Alameda Clash Report

**ASU Alameda
Warehouse**

ID [1](#)

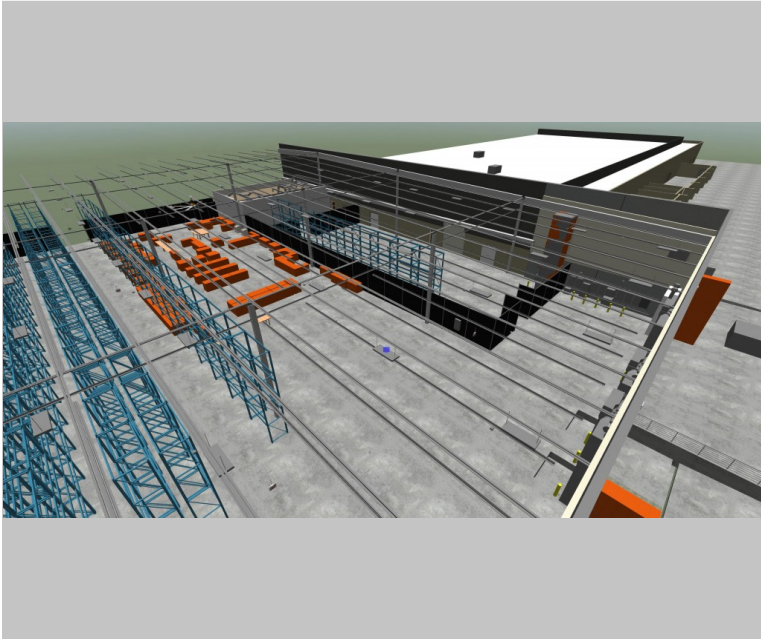
Title
staging area (194) Verify Light Layout and elevations(clashing with joists)

ID [2](#)

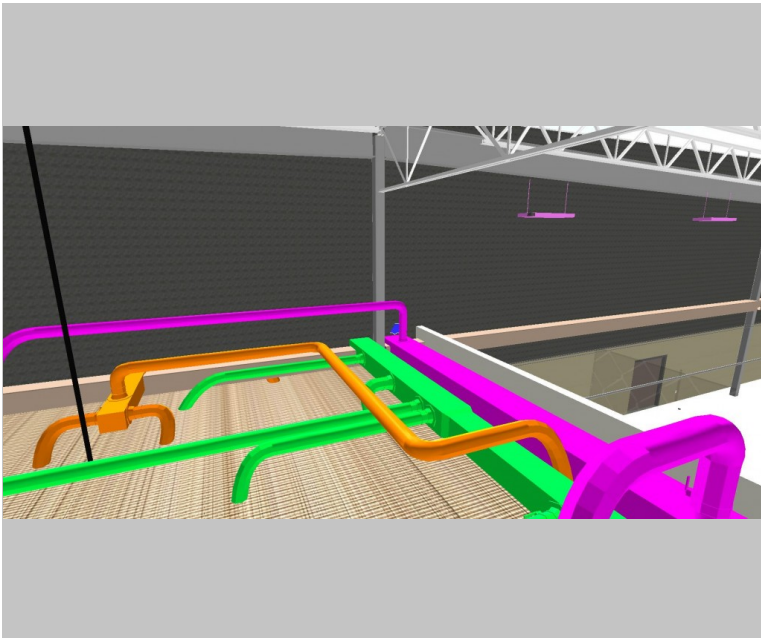
Title
men's restroom (111M1) Confirm Duct Penetration Locations to avoid Beam

ID [3](#) None Open

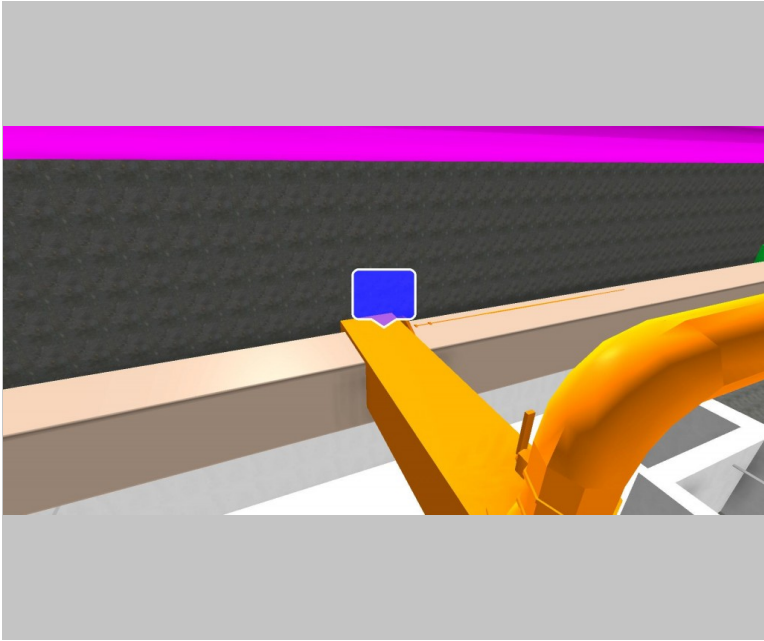
Title
Access Control (113U1) Exhaust duct going through a beam, coordination needed

ID [4](#) None Open

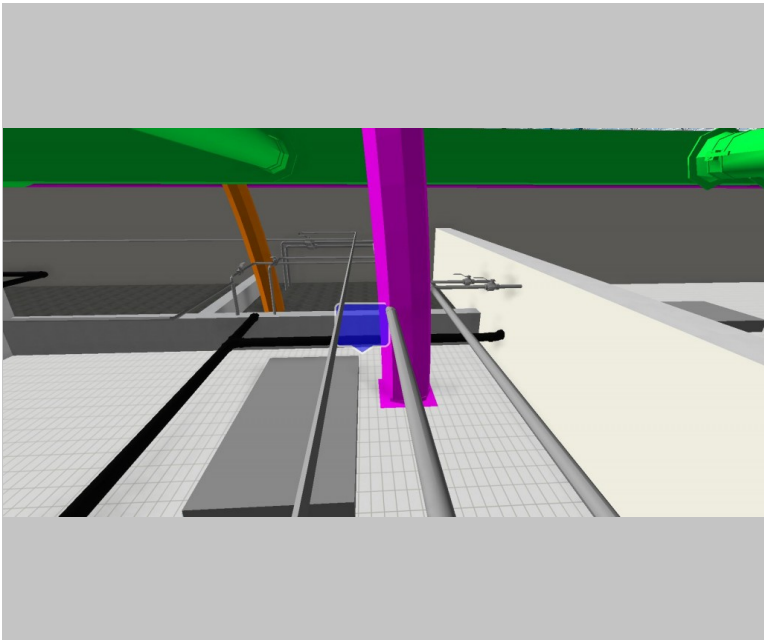
Title
Lockers room(111V1) Return round duct clashing with domestic cold water pipe, positioned too close to the light fixture

ID [5](#) None Open

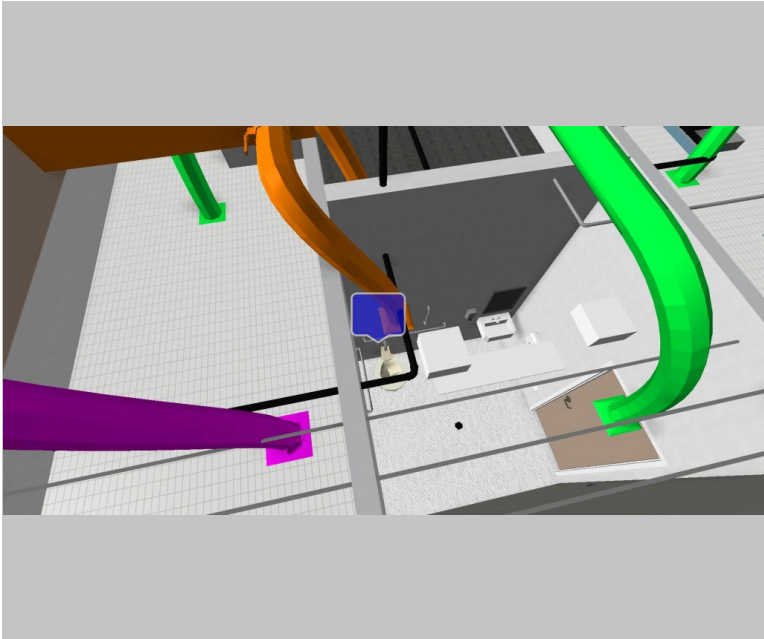
Title
Women's restroom(111W1) Return and Exhaust duct clashing with sewer pipe and domestic cold water pipe respectively

ID [6](#) None Open

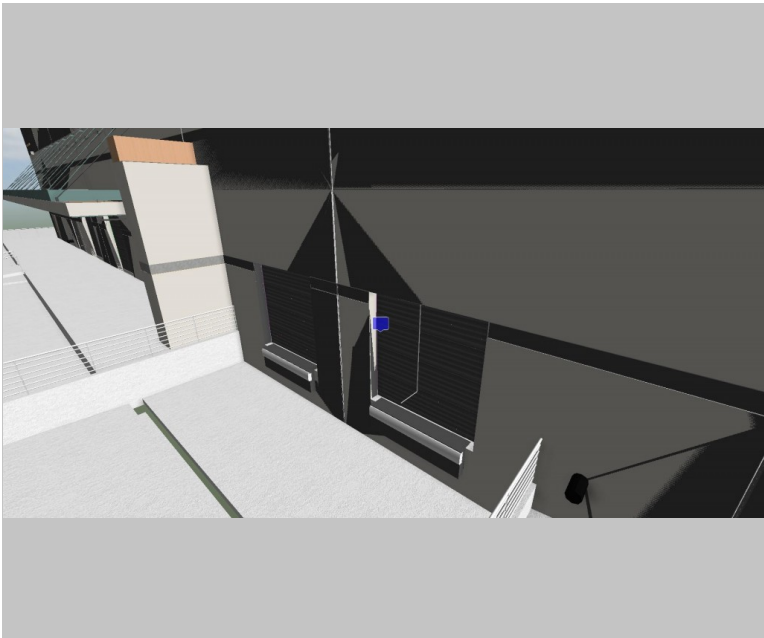
Title
Receiving room (190) Hose bib located at rolling door (190c)/ pipe clashing with door

ID [7](#)

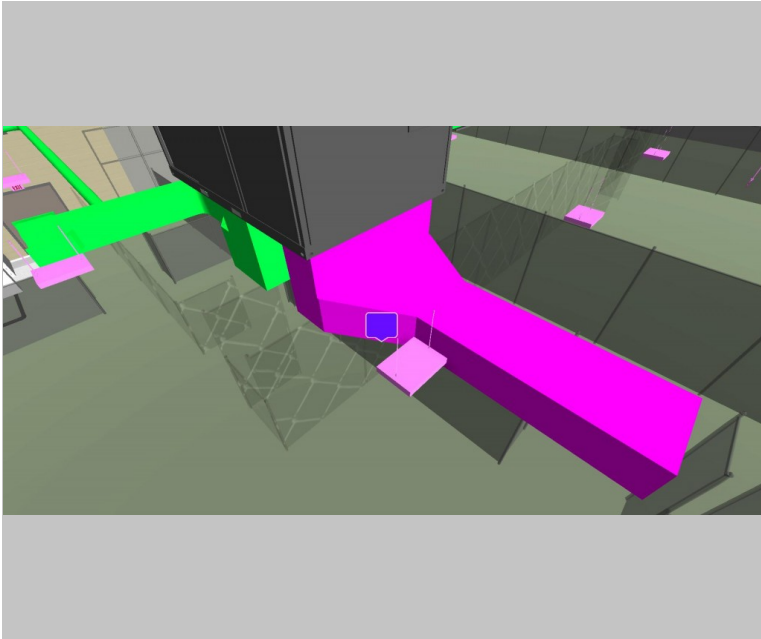
Title
Auction area(182) Light Fixture clashing with a return duct

ID [8](#)

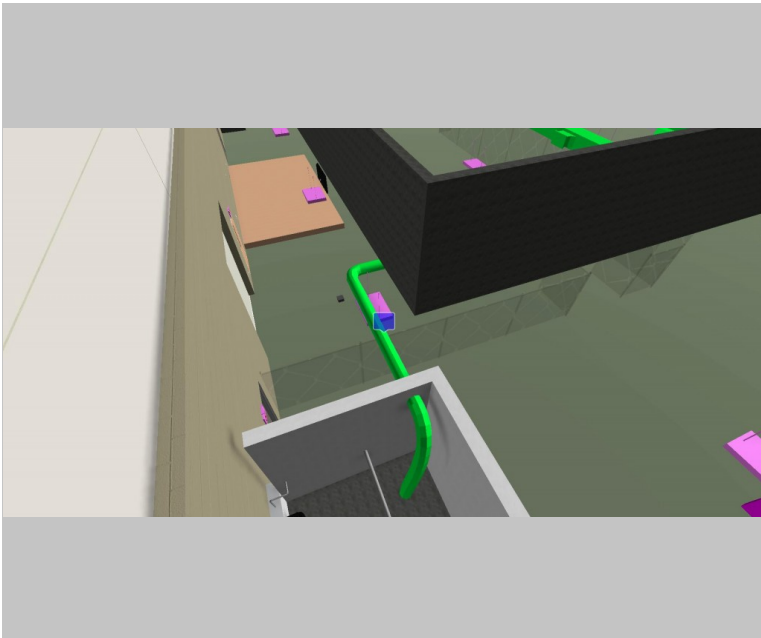
Title
Unisex restroom (180T) Light fixture clashing with a supply duct

ID [9](#)

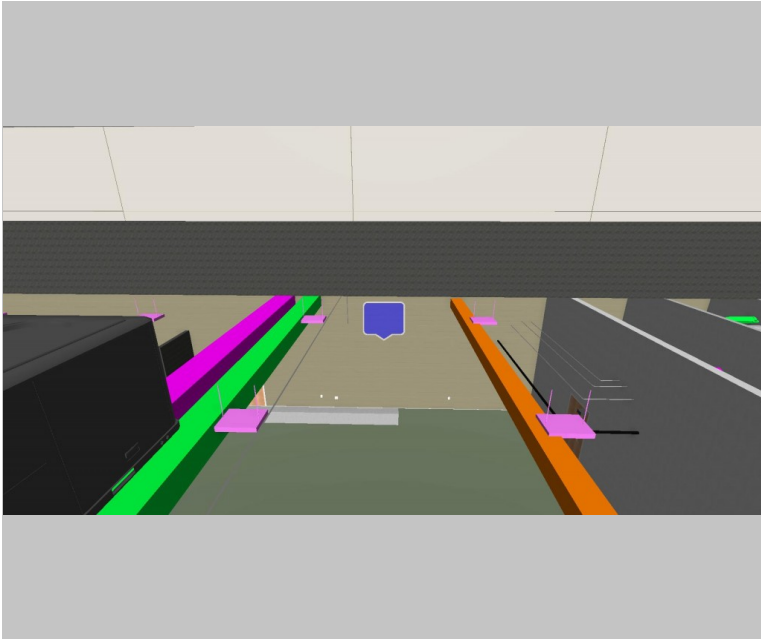
Title
Auction space(182) Multiple light fixtures clashing with return and exhaust ducts.

ID [10](#)

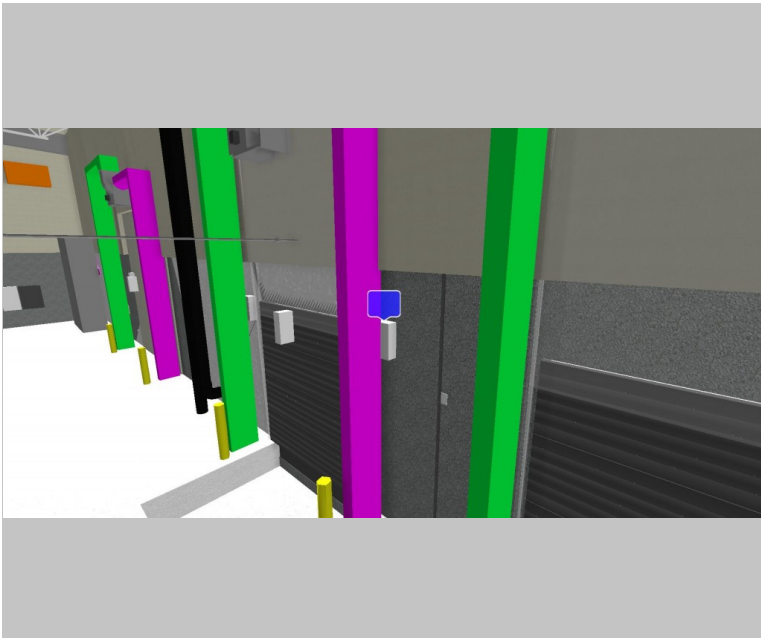
Title
Receiving area(190) near door 190D Electrical fixture clashing with a vertical return duct.

ID [13](#) None Open

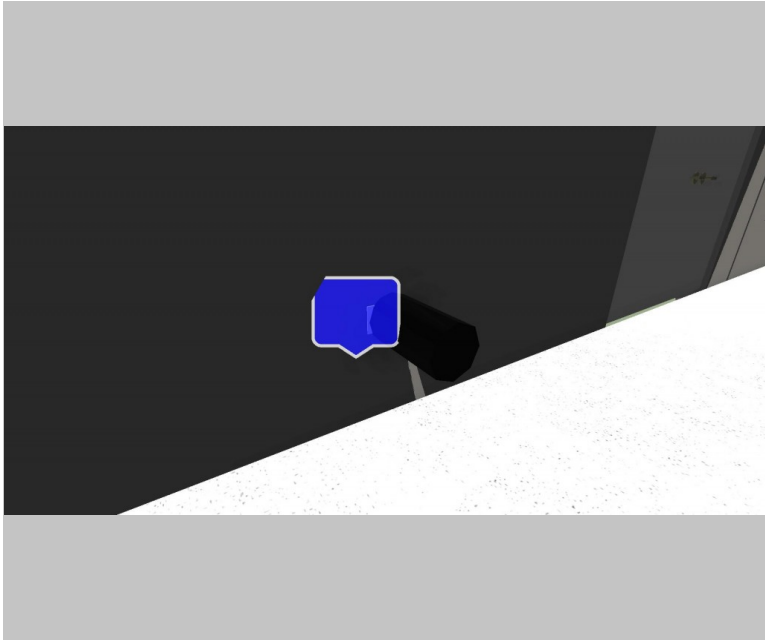
Title
Maintenance/staging area (194) 8" Drainage pipe clashing with electrical fixture GFCI Duplex Receptacle.

ID [14](#) None Open

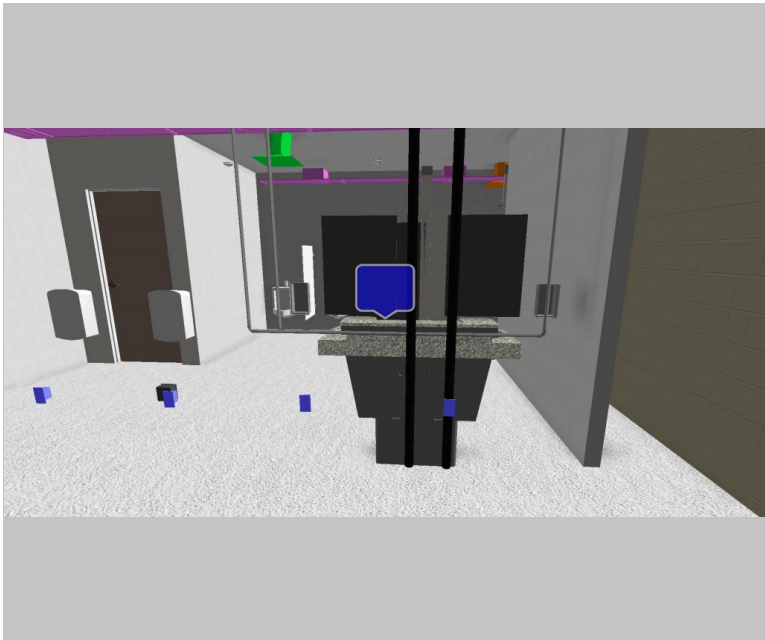
Title
Tech area(191A) Electrical fixture clashing with 2" Sewer pipe.

ID [15](#) None Open

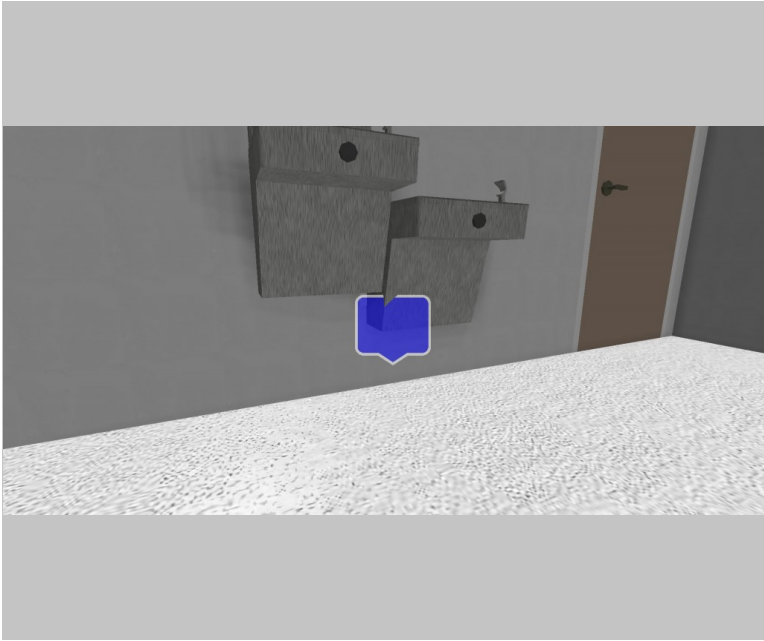
Title
lockers area(111V1) Behind the two drinking fountains Electrical Fixture clashing with a 2" sewer pipe.

ID [18](#) None Open

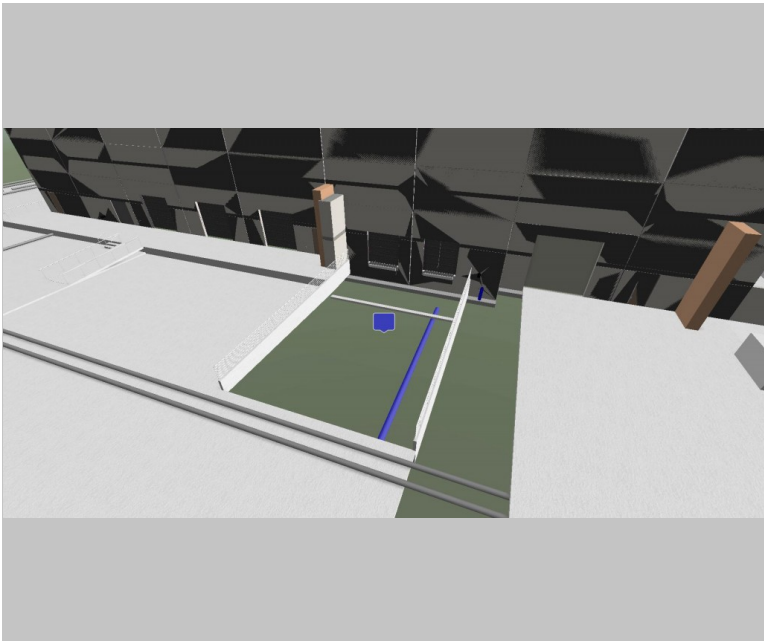
Title
Loading dock-Receiving area (190) Miss alignment between underground drain storm location and drainage pipe coming from the roof.

ID [19](#)

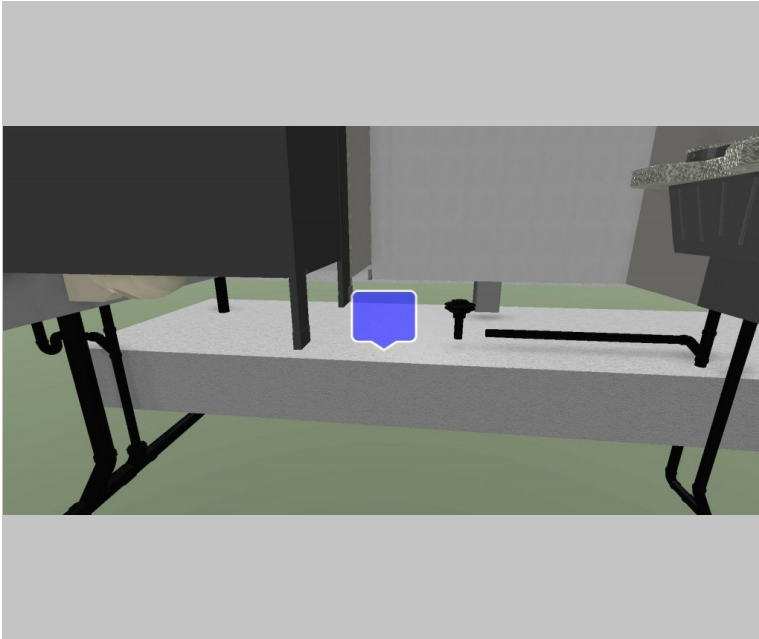
Title
Men's restroom (111M1) Multiple Sanitary pipes going through the footing.

ID [20](#)

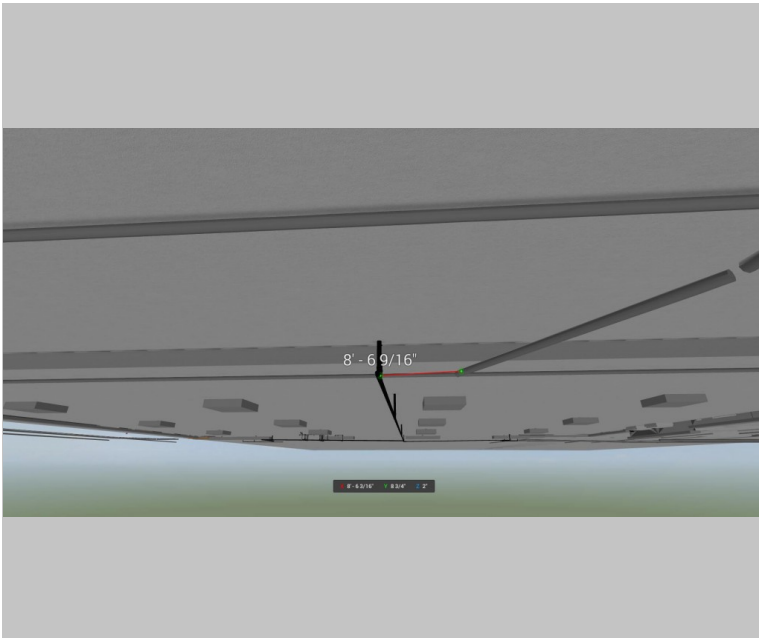
Title
Managed area (195) Sewer main pipe is miss aligned with sanitary pipe coming from the restrooms to the north of the building by 8' 6".

ID [22](#)

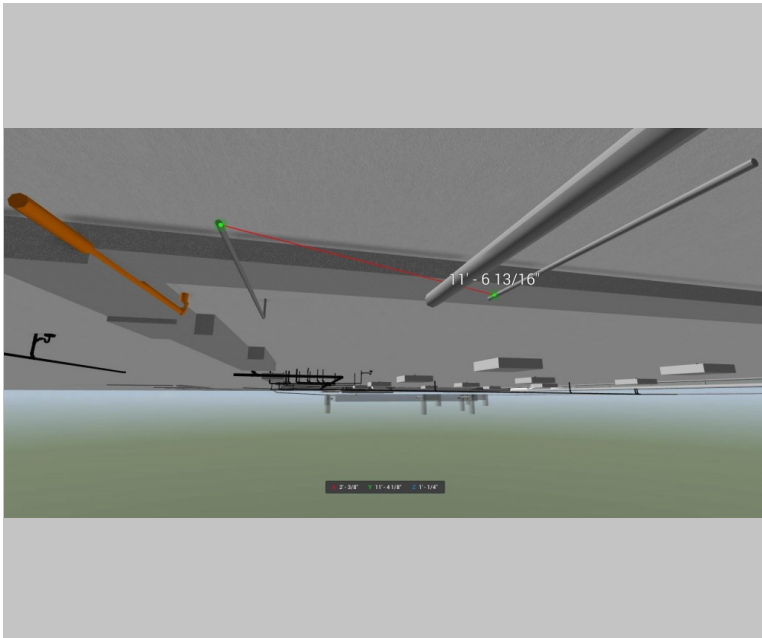
Title
Self Managed area(104) Domestic water pipe is miss aligned by 11'4".

ID [23](#)

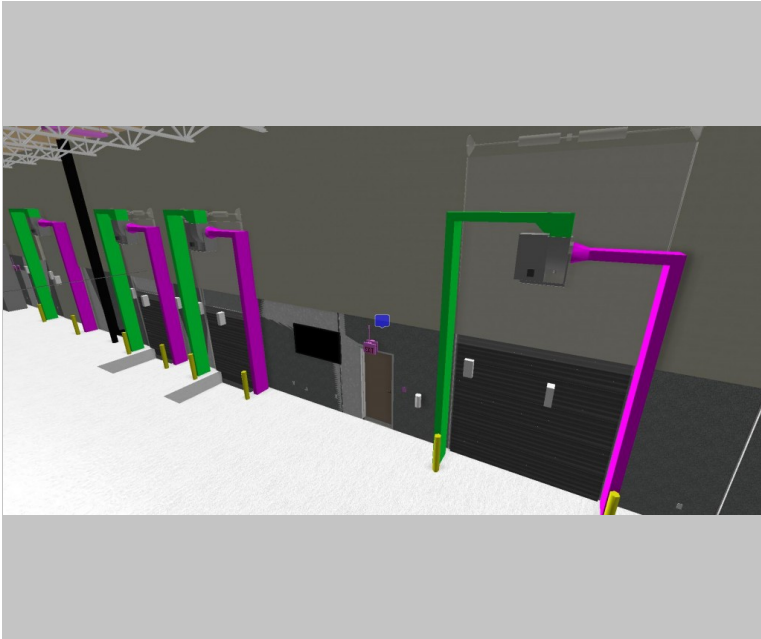
Title
Staging area(194) Verify duct work placement against rolling door railings

ID [24](#)

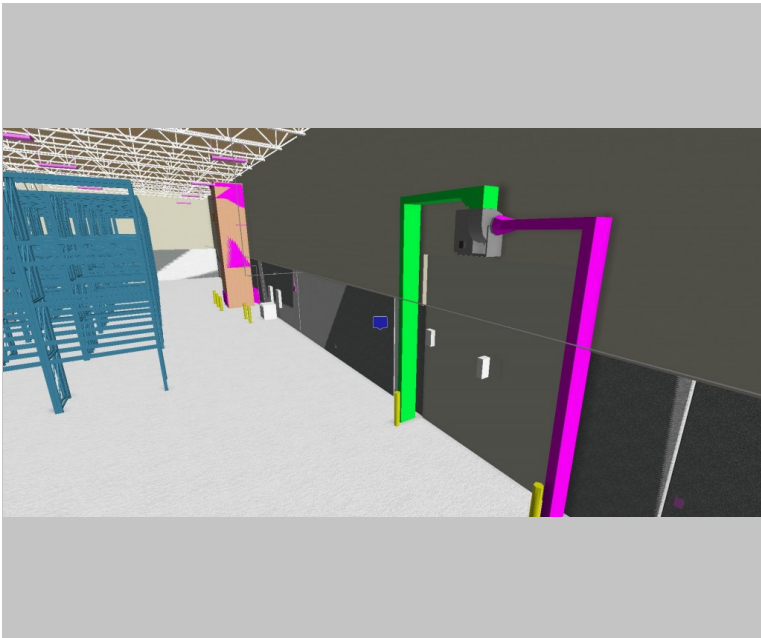
Title
Moving area(108) verify duct work placement against rolling door railings
